Preliminary Report

Critique of the BCRET Project Evaluating the C&H Hog Farm Impact on Big Creek

Report to BRWA

By Michael D. Smolen

Figure 1. Analysis of sampling coverage of flows with mean daily discharge greater than 100 cfs. Shown is concentration of TP in samples from the downstream sampling site on Big Creek and the mean daily discharge at Mt Judea USGS gage.

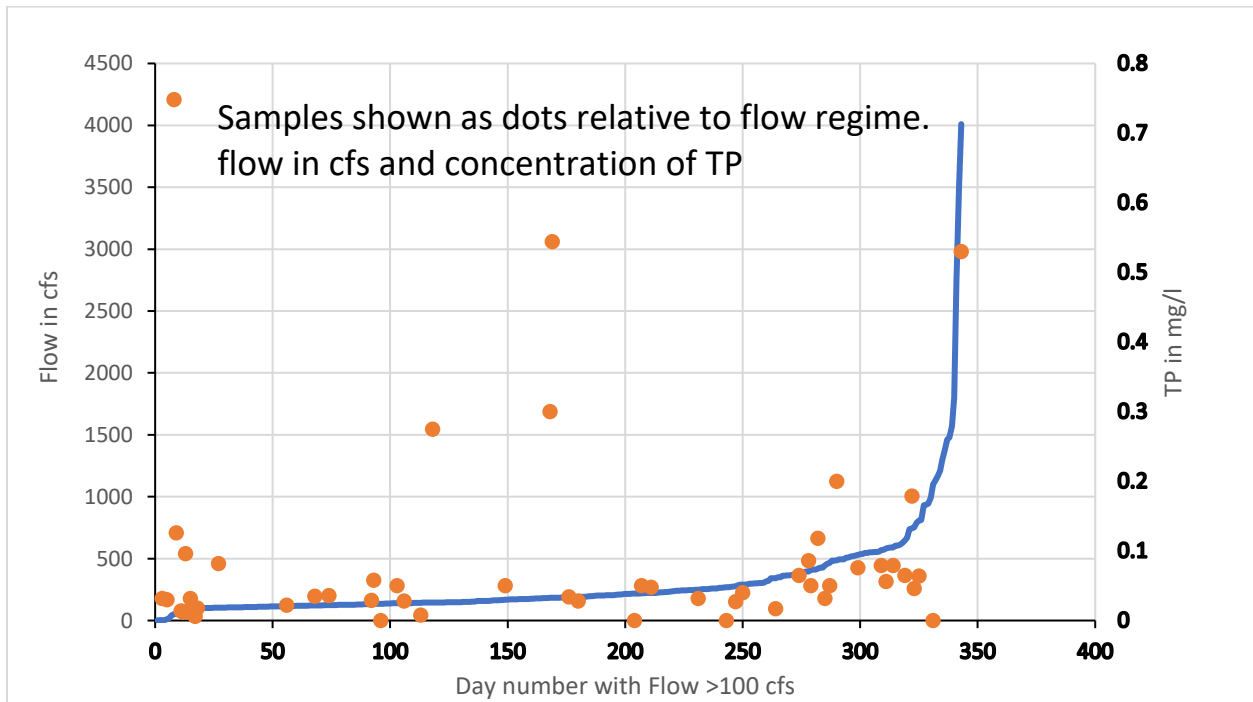
Figure 1 shows the distribution of samples with respect to flow regime. It indicates good coverage of flows in the low to intermediate range (up to about 300 cfs), but not so good at high flows. The full record shows that elevated flows frequently went on from two to five days and peak flows were often missed, even when the automatic samplers were operating. BCRET took samples (storm, base, grab, or storm grab) on only 37 of the days with elevated flow, and only nine grab samples were taken when mean daily flow exceeded 500 cfs.

Figure 2 Concentration of TP upstream and downstream versus flow at Big Creek station. Concentration is in micrograms/l.

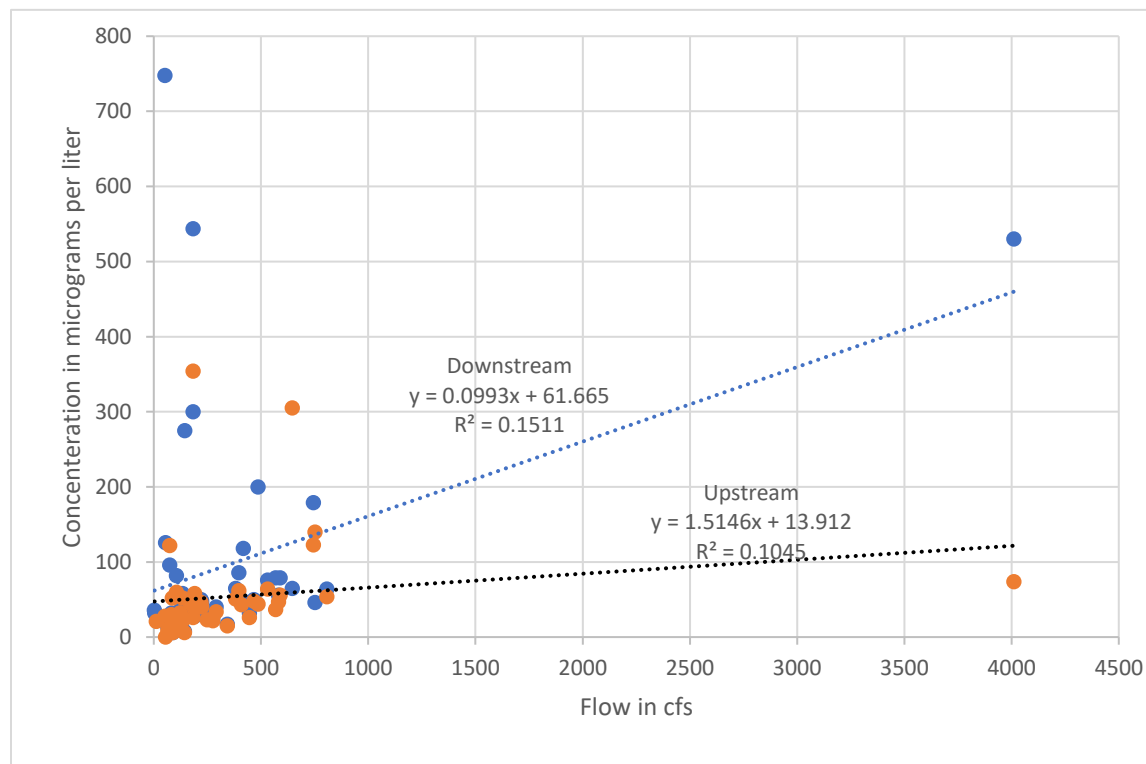
Figure 2 shows the relationship of concentration of TP versus flow at the upstream and downstream stations. Note the steeper slope at the downstream station compared with upstream. This suggests stronger influence of flow on concentration, typical of a surface washoff transport mechanism. Variation of TP concentration at the low flow end of the graph may be explainable by waste application to fields or other factors not recognized in the BCRET reports. No analysis of application and rainfall timing effect on concentration was presented.

Figure 3. Regression of concentration of Nitrate-N versus Flow at upstream and downstream stations on Big Creek. Flow from Mt Judea USGS gage. Concentration is in micrograms/l.

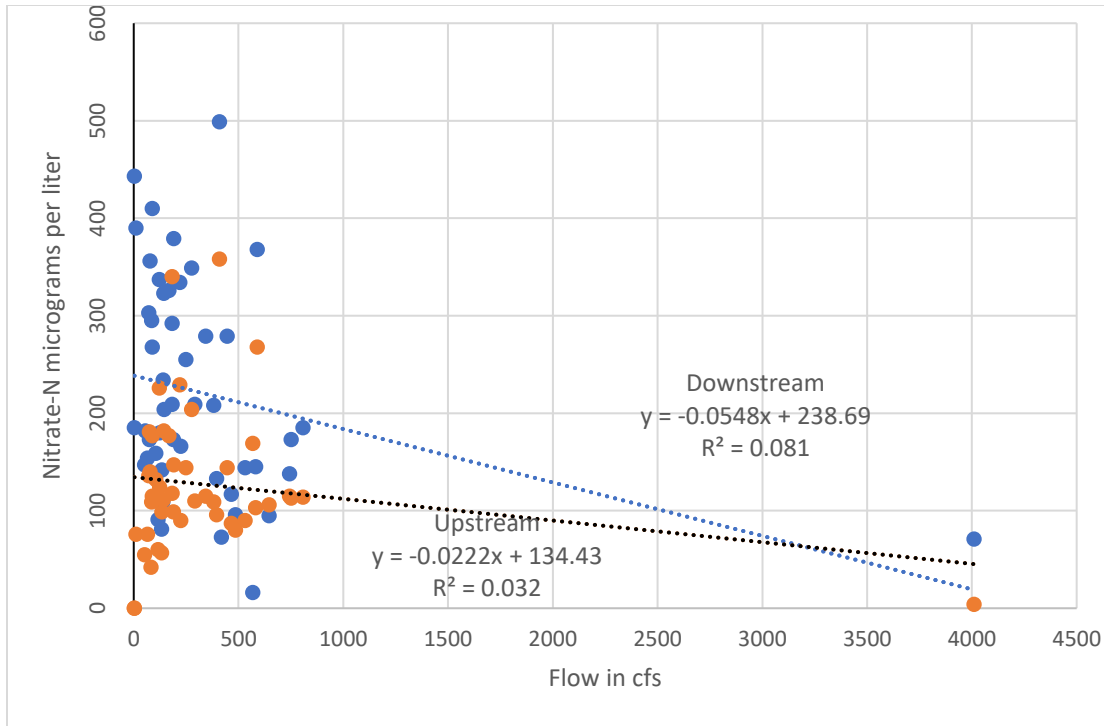
Figure 3. shows the analysis for Nitrate-N concentration versus flow. As expected, Nitrate concentration decreases with flow, suggesting a subsurface route of transport. Once again, the higher values are at the downstream station, near the sources of effluent application. Nitrate-N concentration may be influenced by season as well as land use.

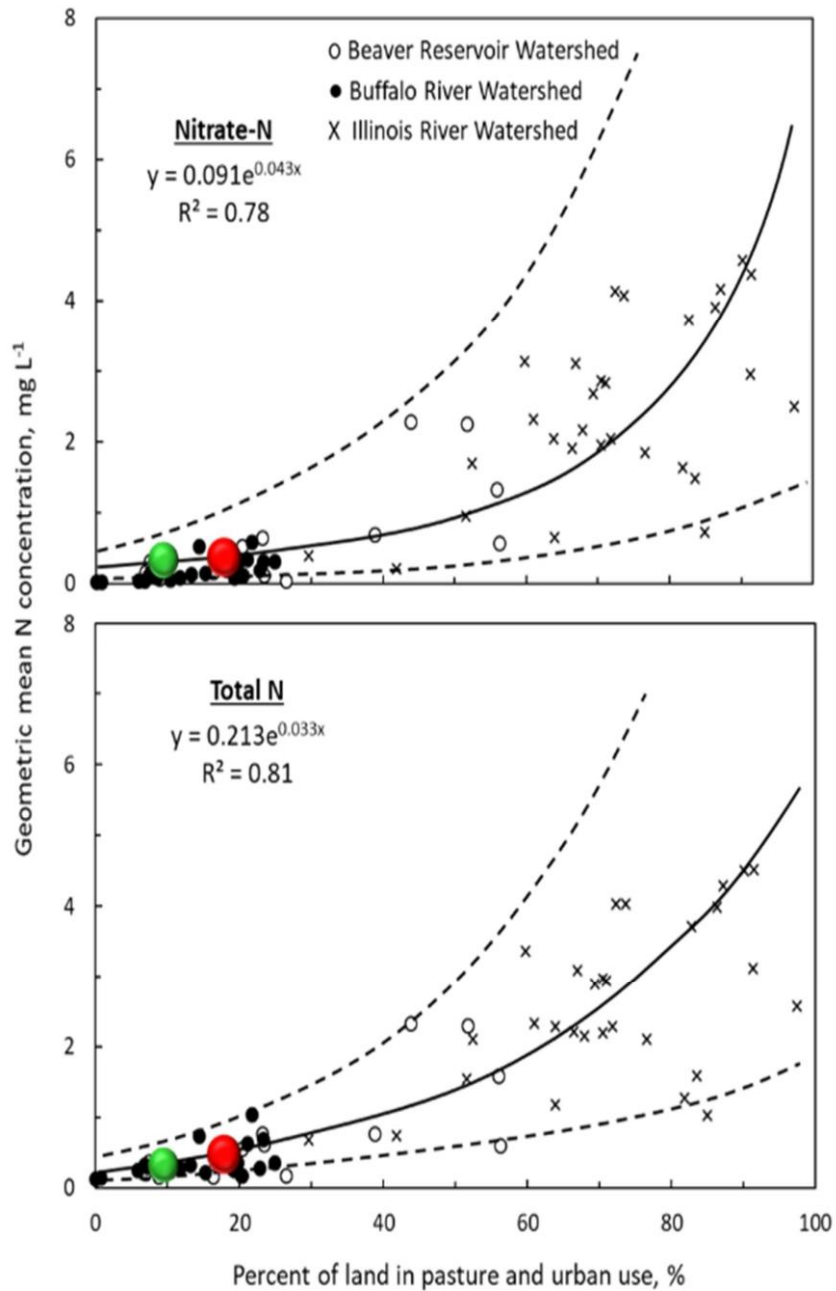
This conclusion relates to the regional analysis presented in the April 1 to June 30 BCRET Quarterly Report (p 40-55), "Relating Land Use and Nutrient Concentrations in Streams of Ozark Mountain Watersheds." The comparisons offered by BCRET, the Illinois River and Beaver Lake, (reproduced here in Figure 4) have much higher involvement of fertilized pastures than does the Big Creek watershed, either upstream or downstream. This analysis places both stations of Big Creek at the low end of the graph, deemphasizing the differences between upstream and downstream. Further, the Big Creek observations of BCRET are relatively insensitive to the impact of the C&H facility because of the large dilution from forested areas.

Peterson (Peterson, 2018) conducted similar analysis with more extensive statistical analysis. I fully support Peterson's conclusions. Peterson points out that the differences between upstream and downstream TP and Nitrate behavior are not explainable by the analysis used by BCRET, but that the results are indicative of the larger influence of C&H farms. I agree with this assertion.
